**Oregon State Agency Comments  
Oregon LNG and Washington Expansion Projects  
Draft Environmental Impact Statement  
CP09-6-001; CP09-7-001; CP13-507-000  
October 5, 2015**

# Oregon State Agency Comments

## Oregon LNG and Washington Expansion Projects

### Draft Environmental Impact Statement

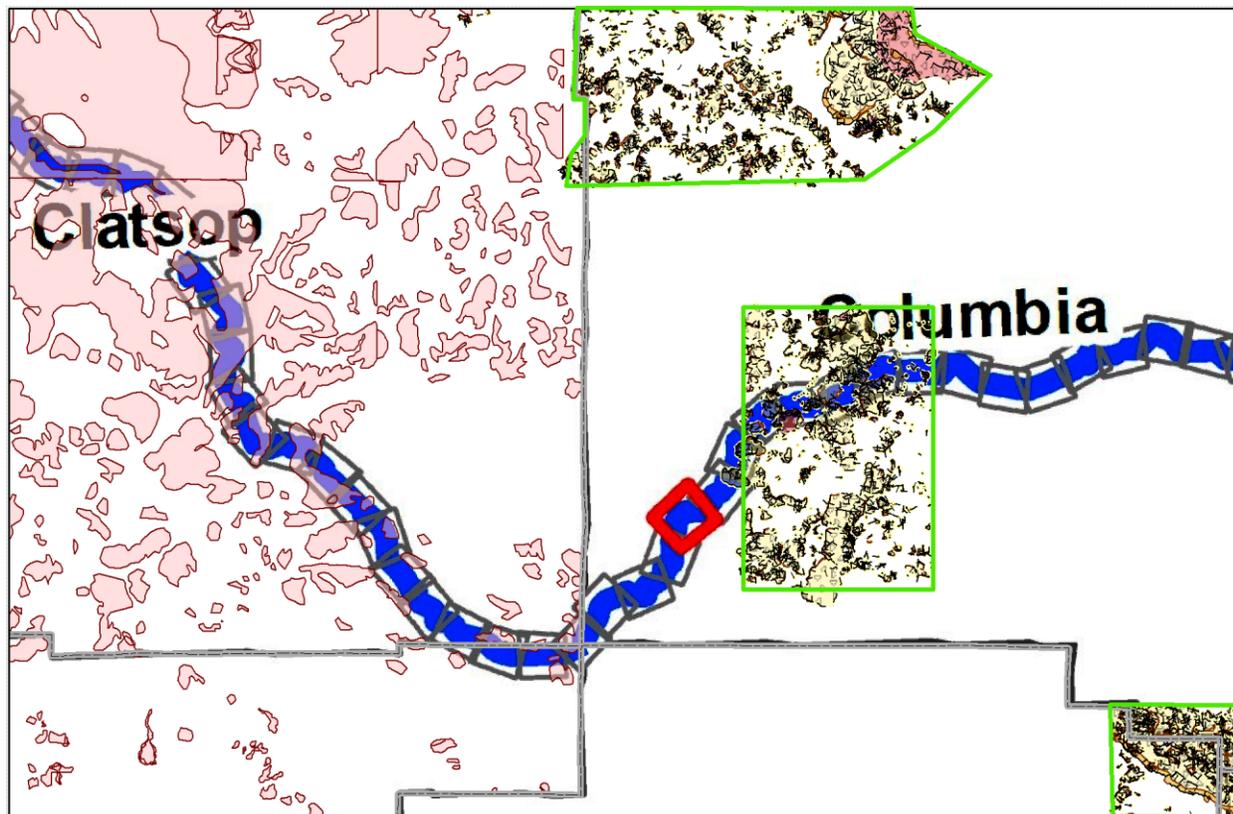
10	Appendix G2, Landslide Hazard Areas Crossed...	SLIDO 2	The latest version of SLIDO, 3.2 should be used in the final EIS.
11	Appendix G2, Landslide Hazard Areas Crossed...	The use of lidar dramatically improves our understanding of the landslide hazard.	See example in Figure 1 below.
12	Appendix G6, Landslide and Debris Flow...	The DEIS inappropriately focuses on shallow rapid landslides as landslide hazard areas.	The analysis in the final EIS should be focused on the landslide types that are most likely to impact the pipeline.
